REFERENCE: Transfer Application T-13889

In the Matter of Transfer Application	)	FINAL ORDER APPROVING A CHANGE IN
T-13889, Lane County	)	POINT OF APPROPRIATION

WATER RIGHT TRANSFER COVER SHEET

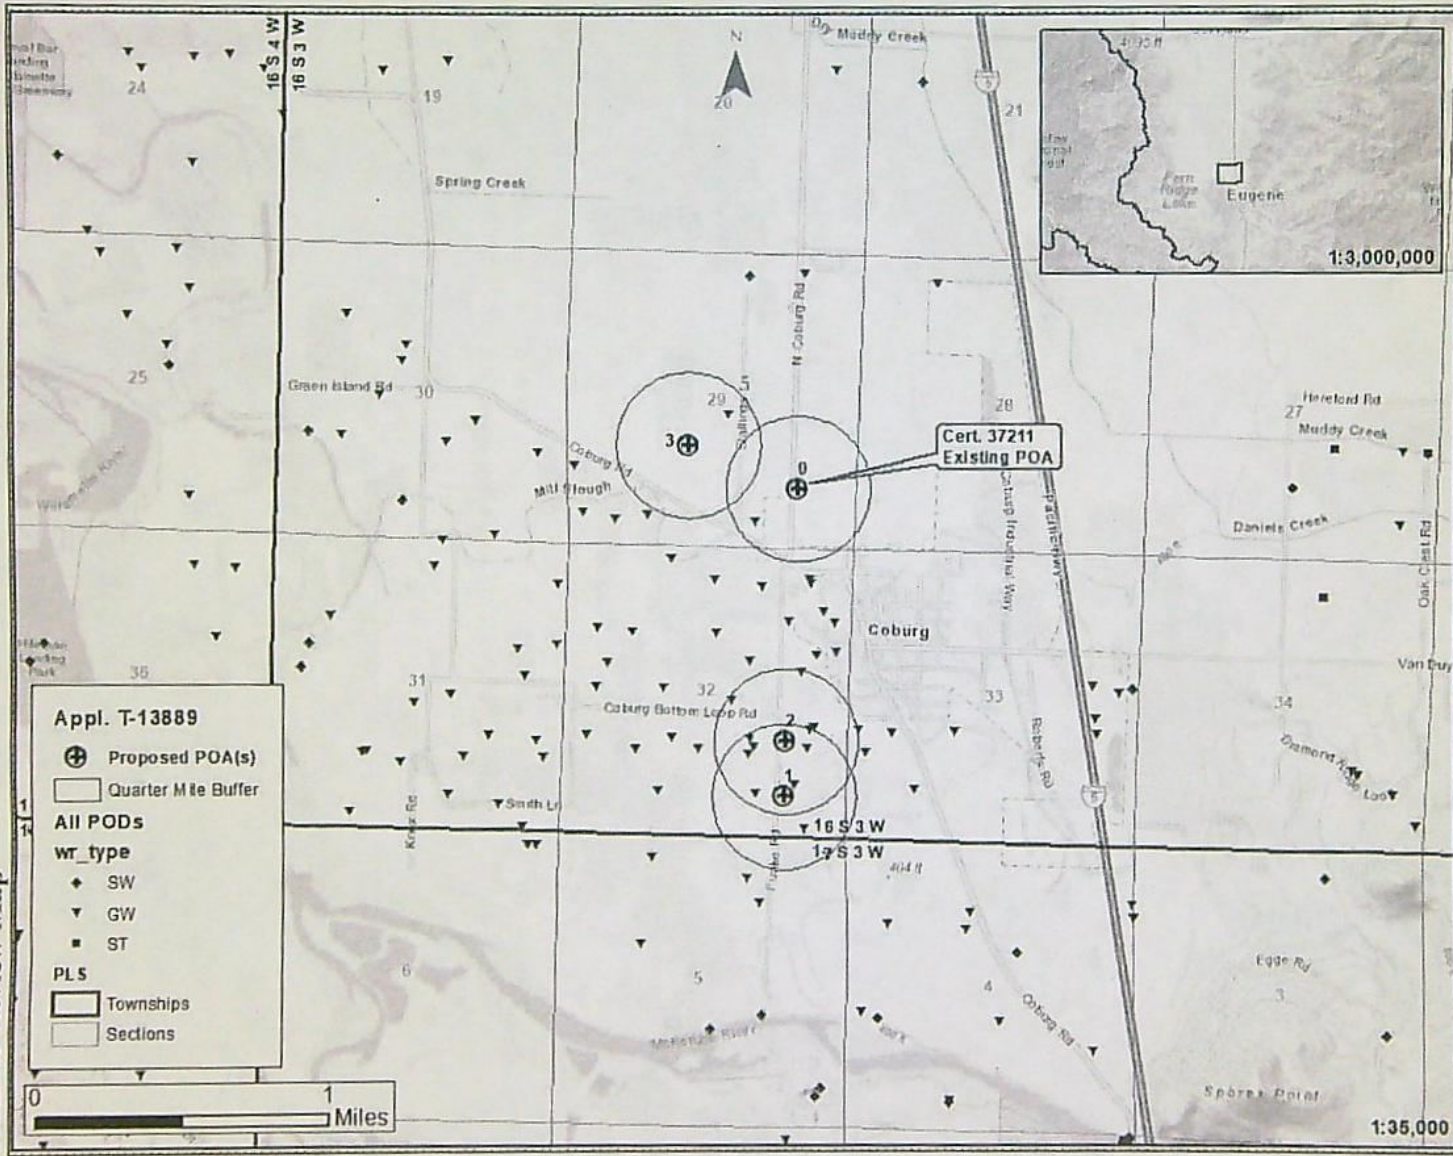
1. Basic description of the changes proposed in this transfer: The application proposes to change the POA on Cert. 37211 from the authorized well (LANE 7556) to three new POAs, two of which are existing wells (LANE 68362 and LANE 7553) and a third which has not been drilled yet.

2. Will the proposed POA develop the same aquifer (source) as the existing authorized POA?
☒ Yes ☐ No Comments: The proposed POAs and existing POAs are producing from alluvial material of the Willamette Valley aquifer system, most likely coarse alluvium associated with the Springfield Fan (Conlon et al., 2005) overlying finer-grained material described as the Lower Sedimentary Unit by Conlon et al. (2005).

4. a) Will this proposed change, at its maximum allowed rate of use, likely result in an increase in interference with **another ground water right**?
☒ Yes ☐ No Comments: The proposed change would move appropriation under Cert. 37211 closer to several existing groundwater rights

5. a) Will this proposed change, at its maximum allowed rate of use, likely result in an increase in interference with **another surface water source**?
☒ Yes ☐ No Comments: The proposed change would move the POAs under the existing certificate closer to the McKenzie River which would increase hydraulic interference with surface water.

- b) If yes, at its maximum allowed rate of use, what is the expected change in degree of interference with any **surface water sources** resulting from the proposed change?
Stream: McKenzie River ☒ Minimal ☐ Significant
Provide context for minimal/significant impact: _____

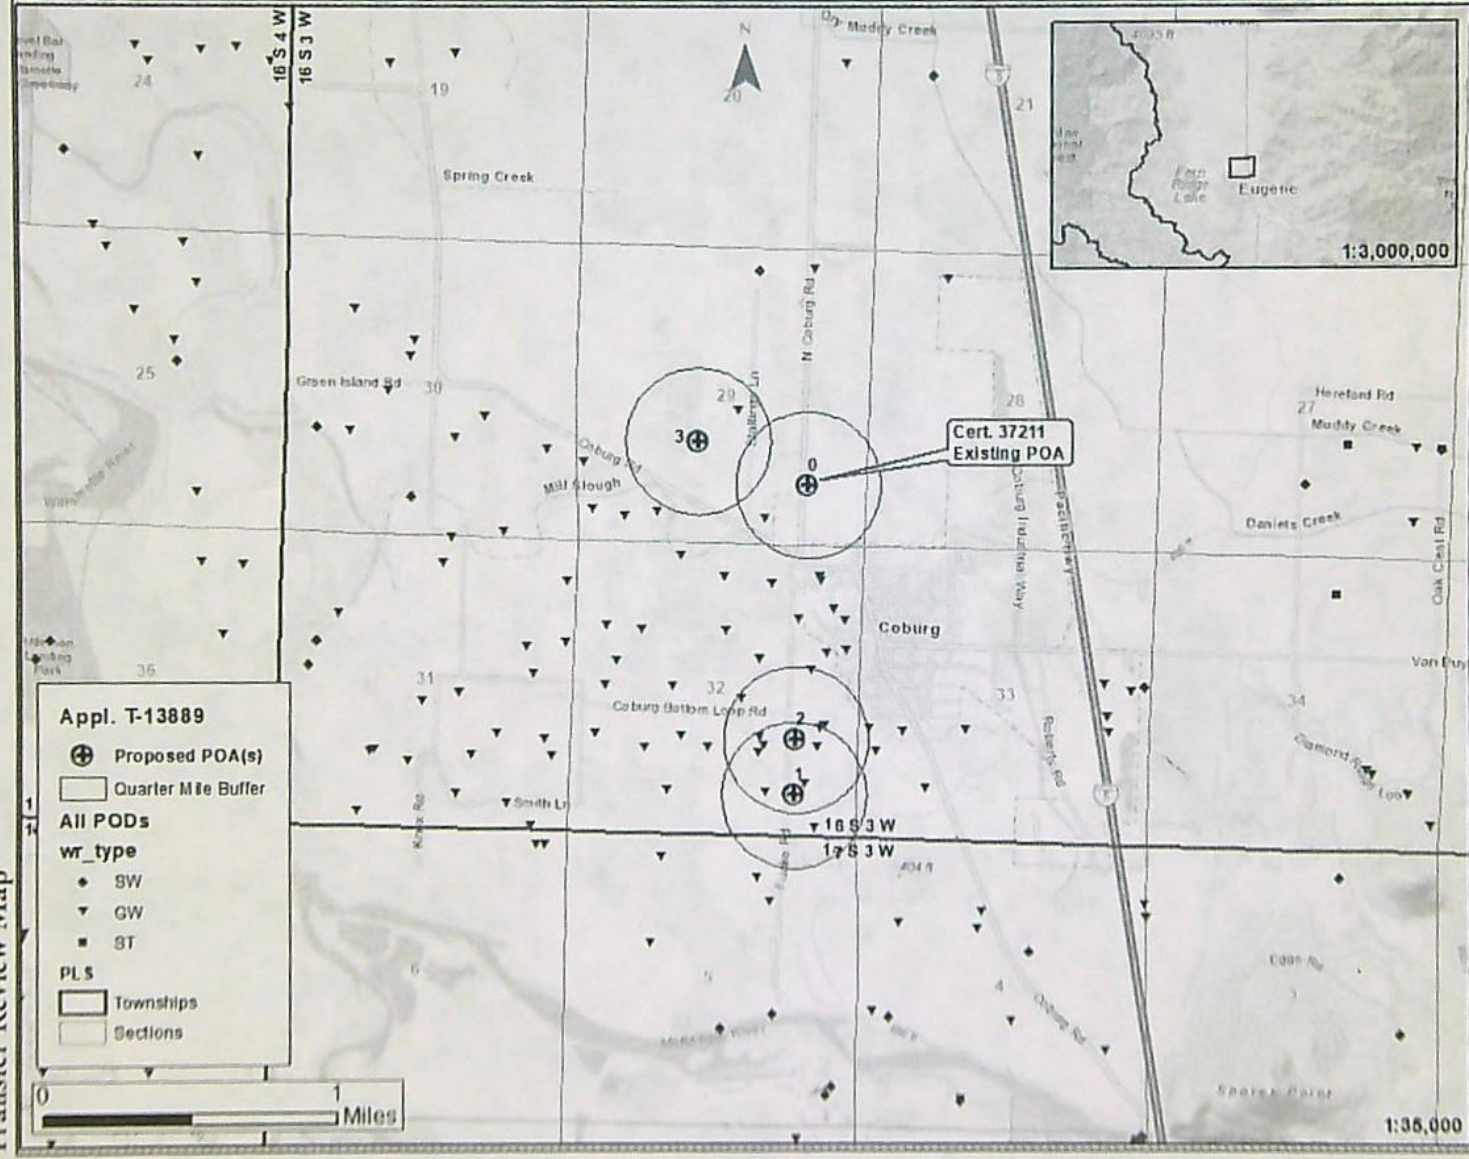
1. Basic description of the changes proposed in this transfer: The application proposes to change the POA on Cert. 37211 from the authorized well (LANE 7556) to three new POAs, two of which are existing wells (LANE 68362 and LANE 7553) and a third which has not been drilled yet.

2. Will the proposed POA develop the same aquifer (source) as the existing authorized POA?
☒ Yes ☐ No Comments: The proposed POAs and existing POAs are producing from alluvial material of the Willamette Valley aquifer system, most likely coarse alluvium associated with the Springfield Fan (Conlon et al., 2005) overlying finer-grained material described as the Lower Sedimentary Unit by Conlon et al. (2005).

4. a) Will this proposed change, at its maximum allowed rate of use, likely result in an increase in interference with **another ground water right**?
☒ Yes ☐ No Comments: The proposed change would move appropriation under Cert. 37211 closer to several existing groundwater rights

5. a) Will this proposed change, at its maximum allowed rate of use, likely result in an increase in interference with **another surface water source**?
☒ Yes ☐ No Comments: The proposed change would move the POAs under the existing certificate closer to the McKenzie River which would increase hydraulic interference with surface water.

- b) If yes, at its maximum allowed rate of use, what is the expected change in degree of interference with any **surface water sources** resulting from the proposed change?
Stream: McKenzie River ☒ Minimal ☐ Significant
Provide context for minimal/significant impact: _____
